## Stage 02: Workgroup Report

### Joint Grid Code and Distribution Code Report

# GC0110: LFSM-O compliance requirements for Type As and B PGMs

**Purpose of Modification:** To update the Grid Code and G99 with revised text for limited frequency sensitive mode- over-frequency compliance so that manufacturers have clear pass/fail criteria for limited frequency sensitive mode-over-frequency compliance.

Figure 1 - +2.0Hz injection with 10% droop setting (initial response)

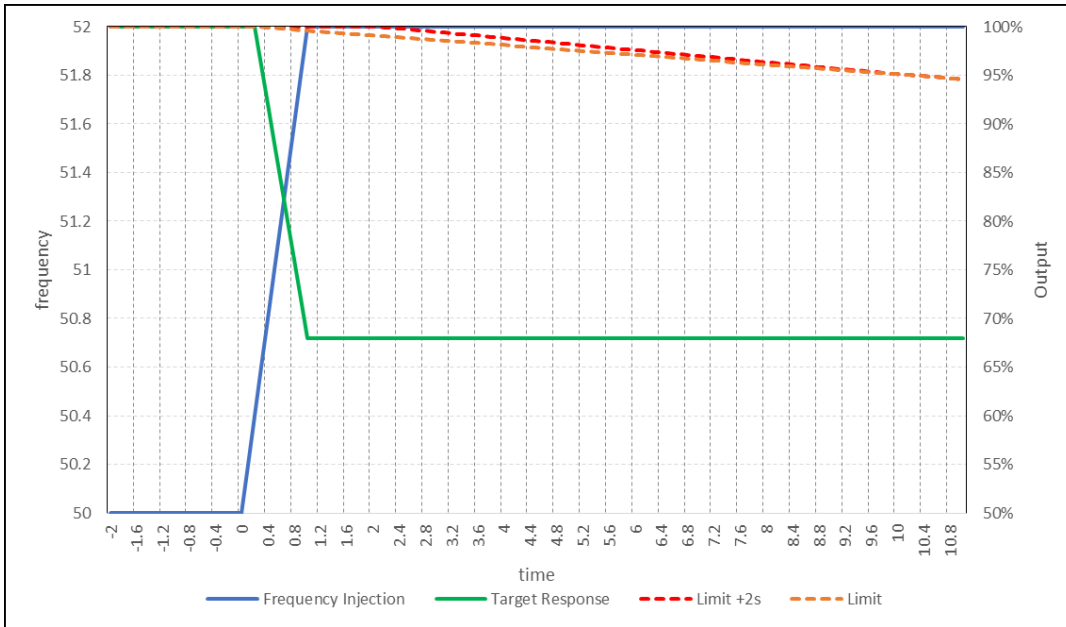
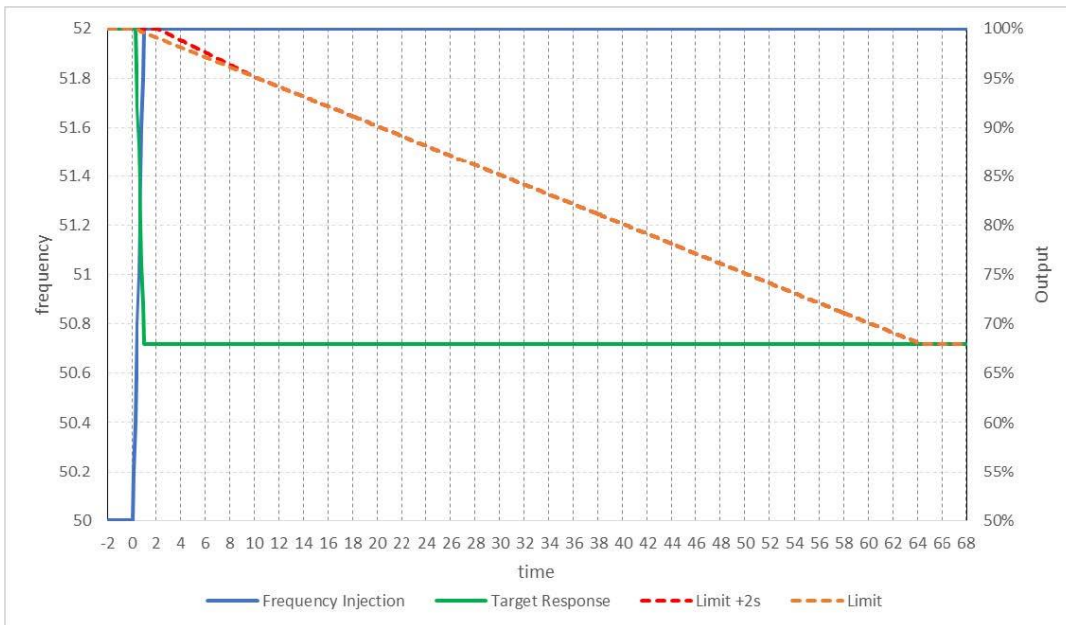
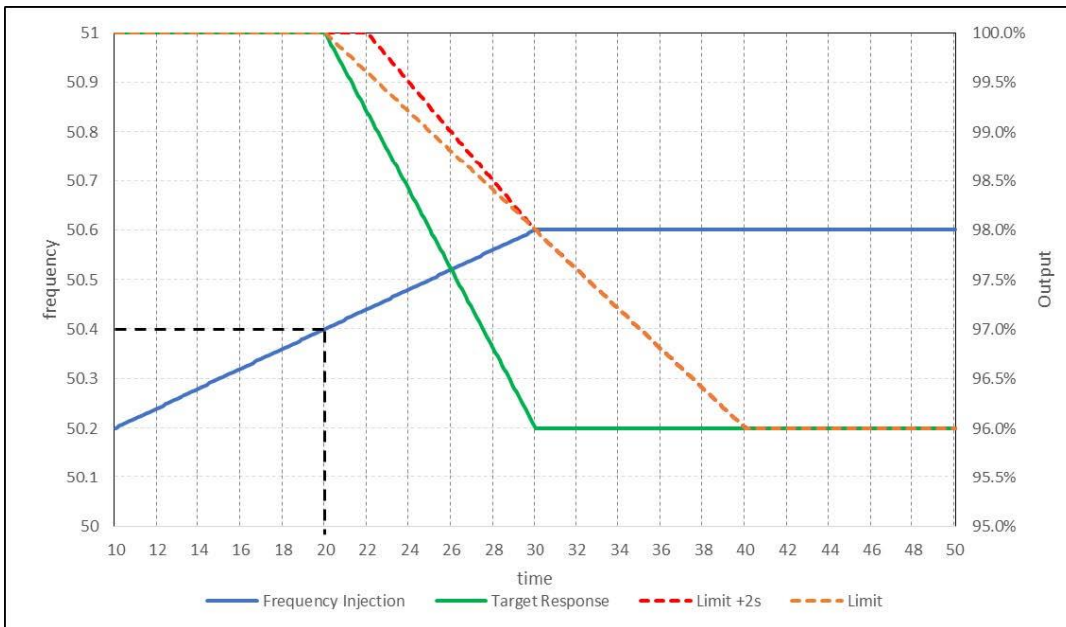
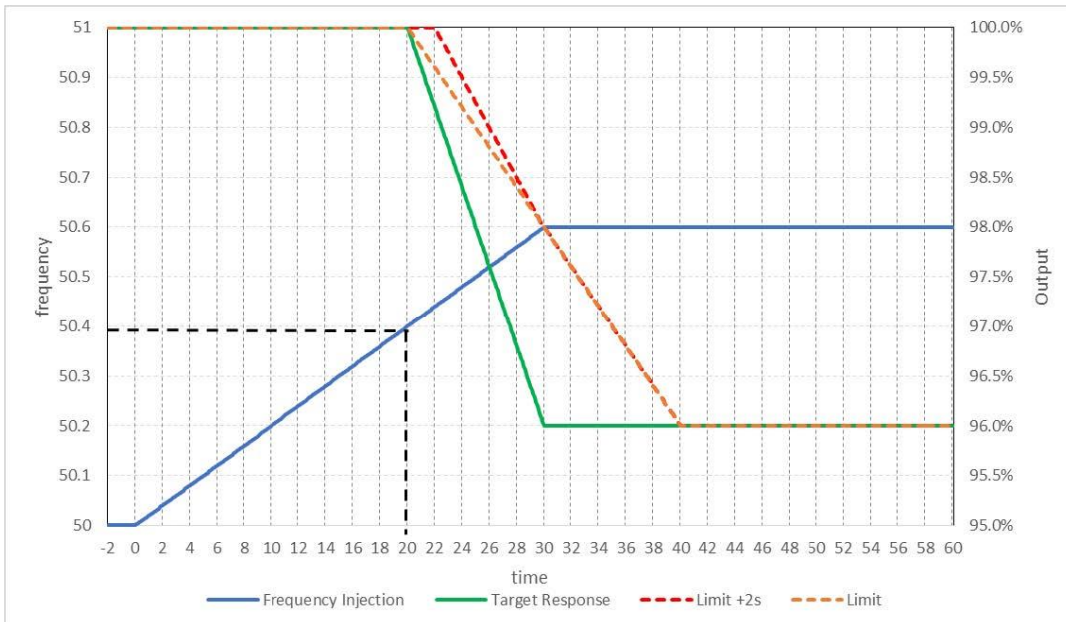
This is indicated graphically for an injection of a +2.0Hz step (as a 1 second ramp) in figures 1 & 2 and for an injection of a +0.6Hz ramp in figures 3 & 4. On the graphs the blue line indicates the injected frequency with the green line

showing the calculated minimum steady state response position in relation to the frequency deviation. The boundary of acceptable minimum response against time calculated in line with the methodology set out above is shown by the red dashed line. The difference between the orange and red lines indicates the permitted two second delay in for the initial measurable response but it is important to note that at the end of the time period (ie at 10 seconds) both the red and orange lines converge to the same point. For the avoidance of doubt any response which is on or below the red line is acceptable.

The Work group also discussed whether the permitted 2 second delay in starting to respond to a frequency change should be allowed to apply after the 10 second activation period and hence change the red lines in figures 1,2,3 and 4 to be parallel to the orange line and not coincide after 10 second. After discussion it was agreed the current interpretation with the lines coinciding after 20 seconds as per the proposal is acceptable.

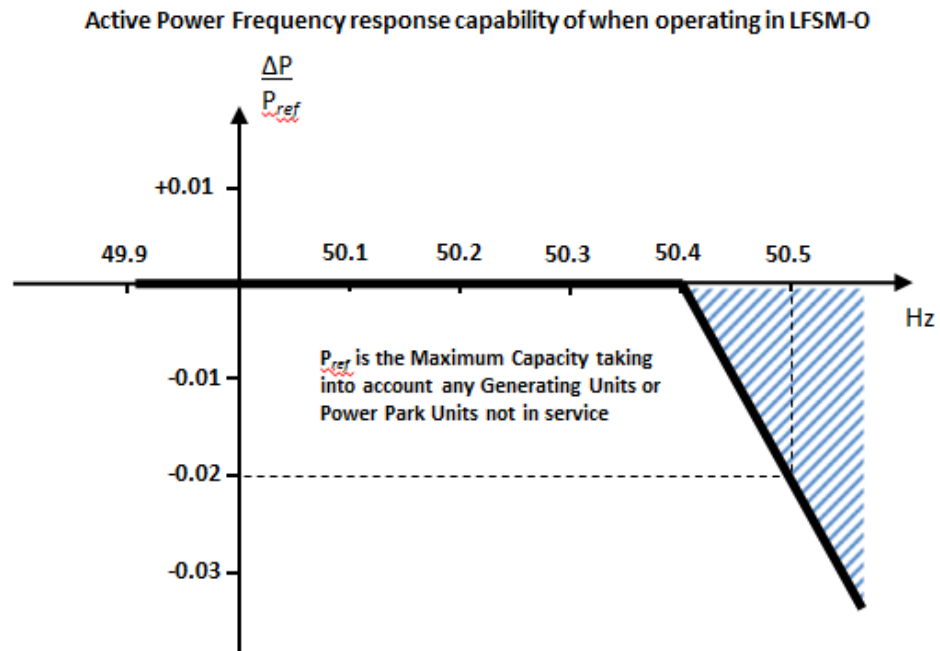
- ECC.6.3.7.1.2
- (i) The rate of change of **Active Power** output must be at a minimum a rate of 2 percent of output per 0.1 Hz deviation of **System Frequency** above 50.4Hz (ie a **Droop** of 10%) as shown in Figure ECC.6.3.7.1 below. This would not preclude a **EU Generator** or **HVDC System Owner** from designing their **Power Generating Module** with a **Droop** of less than 10% but in all cases the **Droop** should be 2% or greater.

- (iii) As much as possible of the proportional reduction in **Active Power** output must result from the frequency control device (or speed governor) action and must be achieved within 10 seconds of the time of the **Frequency** increase above 50.4 Hz. The **Power Generating Module** (including **DC Connected Power Park Modules**) or **HVDC Systems** shall be capable of initiating a power **Frequency** response with an initial delay that is as short as possible. If the delay exceeds 2 seconds the **EU Generator** or **HVDC System Owner** shall justify the ~~delay~~variation, providing technical evidence to **NGET**.

Figure A.7.8(ii): LFSM-O step response test – target response and limits

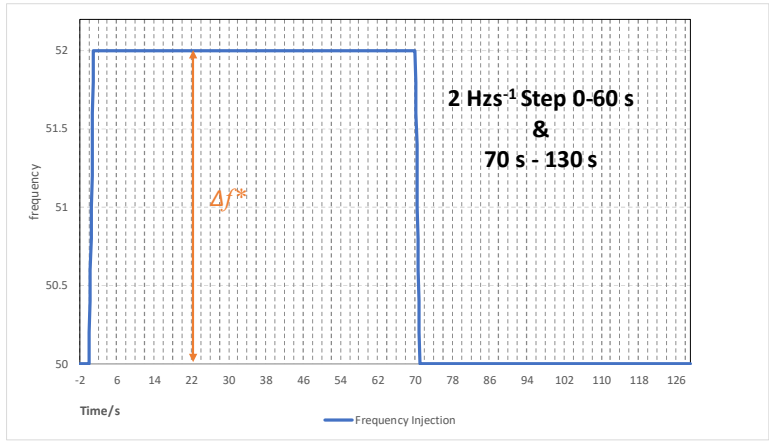
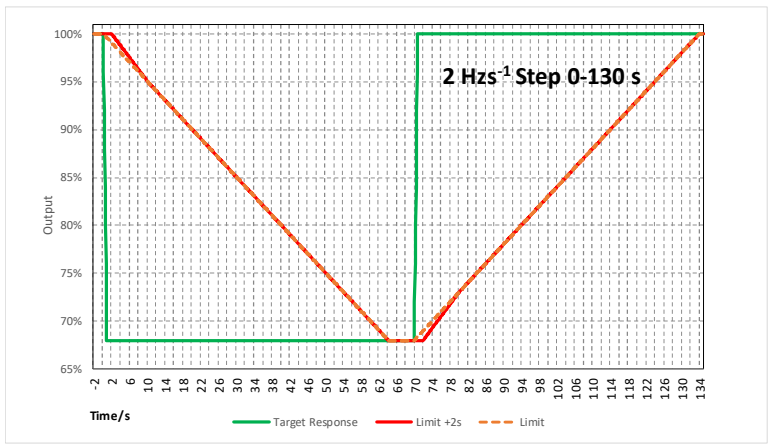
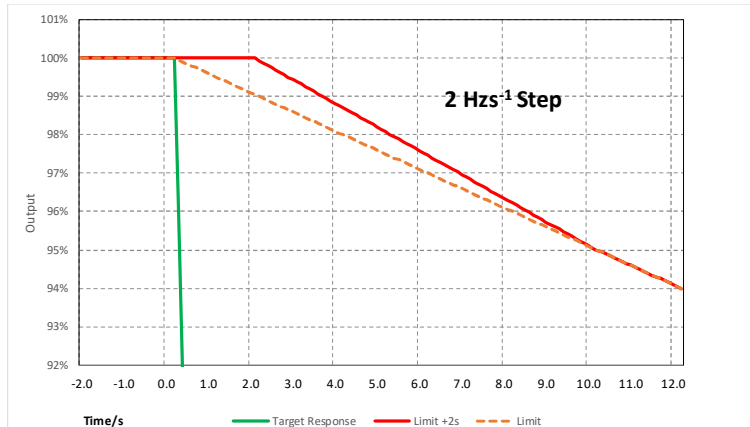
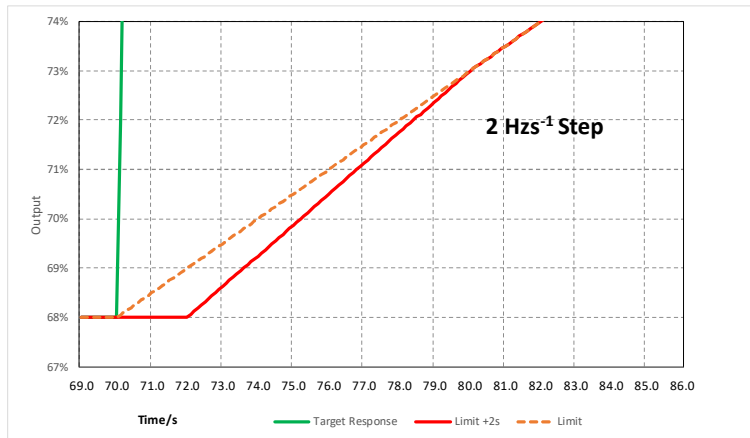
The frequency input and the expected **Active Power** response which is are illustrated for different periods from 0 s to 130 s in Figures A.7.98 for a step change in frequency and in Figures A.7.109 for a ramp change in frequency. This should be in accordance with Section 11.2.4 (a threshold frequency of 50.4 Hz and a **Droop** of 10%) and undamped oscillations should not occur after the step or ramp

The response should commence within 2 s and the response must be to the left of the red line (ie between the green line and the red line), and be as close to the green line as possible, when following the frequency step or ramp. Note that the red line represents the 0.5%/s specified in 11.2.4.1. The response should commence within 2 s (or such time as the DNO might agree with the Generator); ie the response should normally be contained within the blue lines, and as close to the left as possible, when following the frequency ramp. The response should be complete in a reasonable time and the DNO can agree with the Generator a longer completion time than suggested by the blue lines taking into account the technical capabilities of the Power Generating Module and its prime mover.

**Figure B.5.1(ii): LFSM-O step response test – target response and limits**  
**Figure B.5.1(ii): LFSM-O step response test – target response and limits**

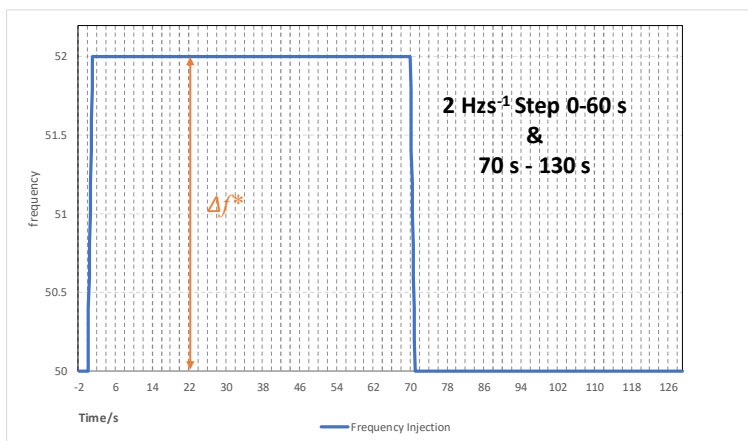
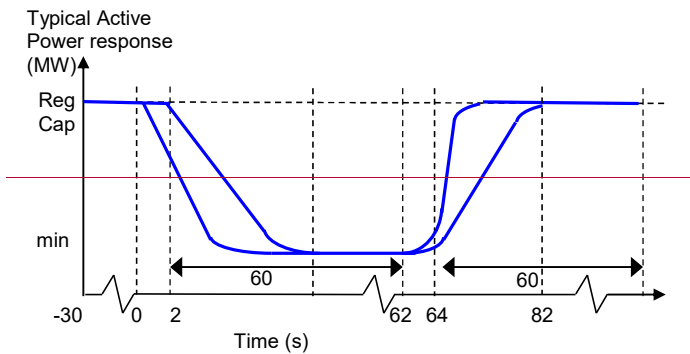
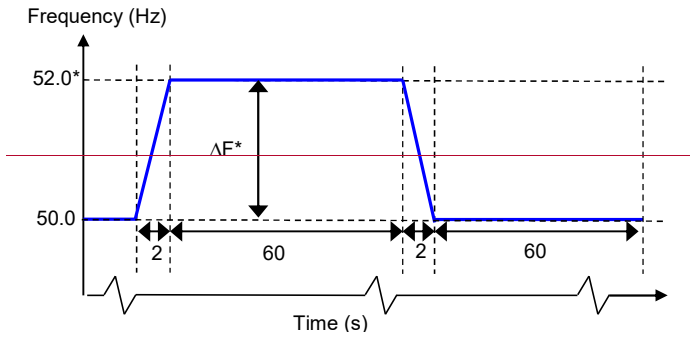
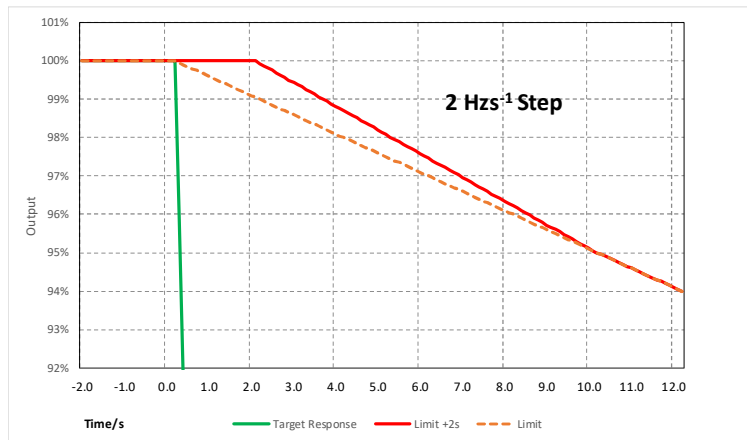
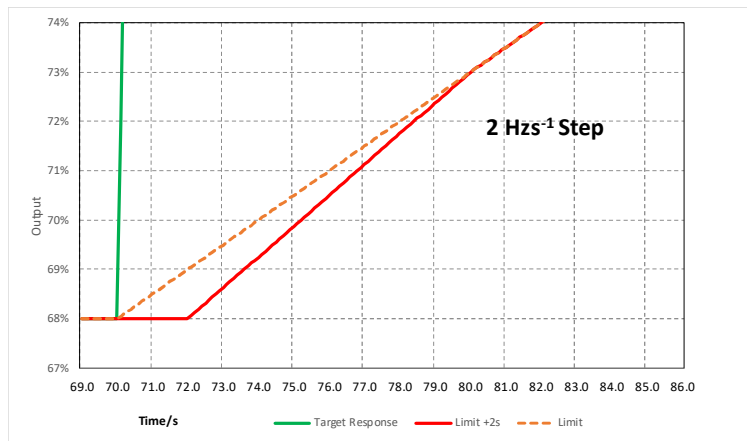
- B.5.6.4 The ~~frequency input and the~~ expected **Active Power** response which ~~is~~ are illustrated ~~for different time periods from 0 to 130 s~~ in Figures B.5.1 ~~for a step change in frequency~~ and B.5.2 ~~for a ramp change in frequency~~. These should be in accordance with Section 12.2.4 and undamped oscillations should not occur after the step or ramp frequency change. Note for diagram purposes only a short interval is shown between the frequency increase and decrease for each test. In practice the return step or ramp can start any time after the output has stabilised after the first step or ramp.

- B.5.6.5 The response should commence within 2 s ~~(or such time as the DNO might agree with the Generator); ie and~~ the response ~~should normally~~ must be to the left of the red line (ie between the green and red line), and as close to the green line as possible, when following the frequency step or ramp contained within the blue lines, and as close to the left as possible, when following the frequency ramp. The response should be complete in a reasonable time and the **DNO** can agree with the **Generator** a longer completion time than suggested by the blue lines taking into account the technical capabilities of the **Power Generating Module** and its prime mover. Note that the red line represents the 0.5%/s specified in 12.2.4.

**Figure B.6.3(ii): LFSM-O step response test – target response and limits**

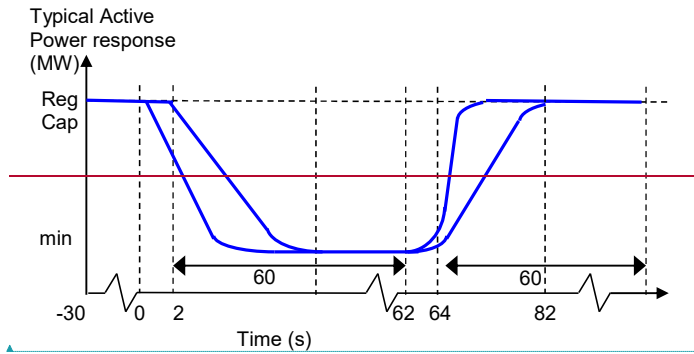
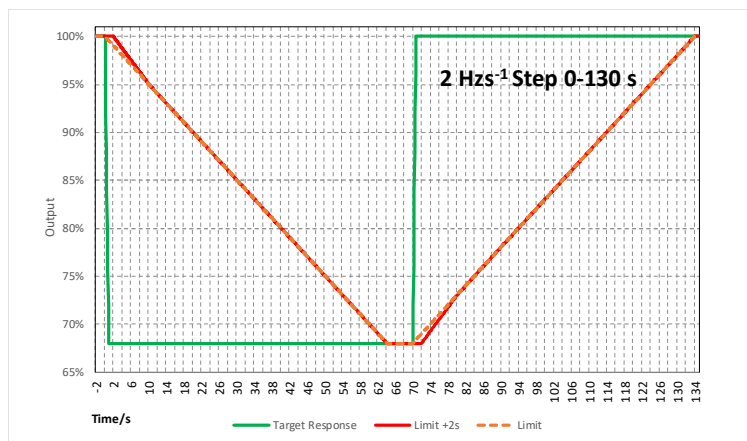
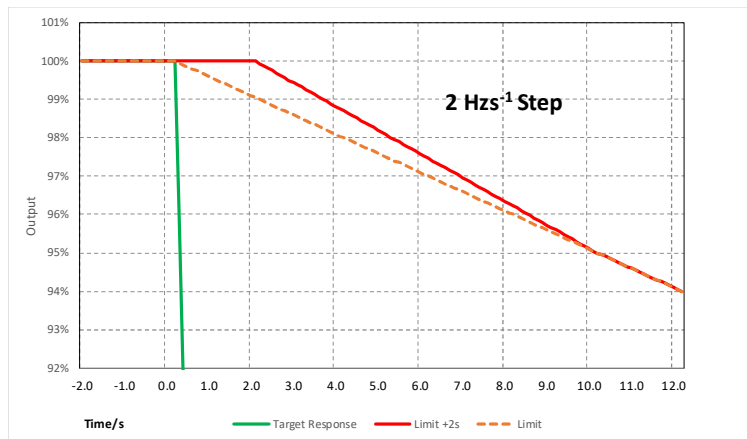
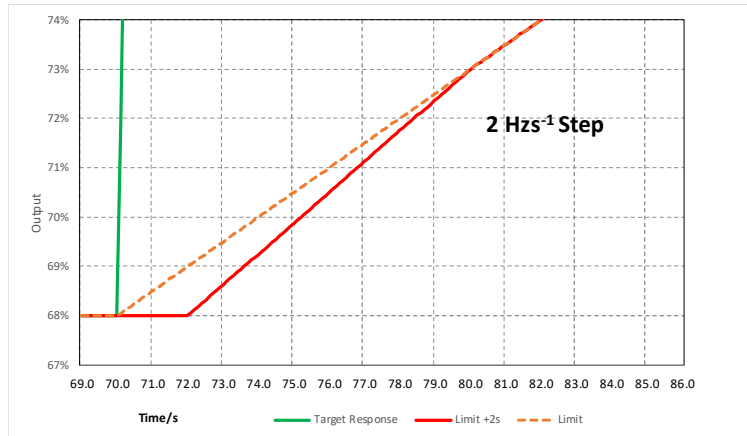
- B.6.5.5 The frequency input and the expected **Active Power** response which are illustrated for different time periods from 0 to 130 s in Figures B.6.3 for a step change in frequency and Figures B.6.4 for a ramp change in frequency. This should be in accordance with Section 12.2.4 and undamped oscillations should not occur after

**B.6.6.5** The response should commence within 2 s and the response must be to the left of the red line (ie between the green and red line), and as close to the green line as possible, when following the frequency step or ramp. Note that the red line
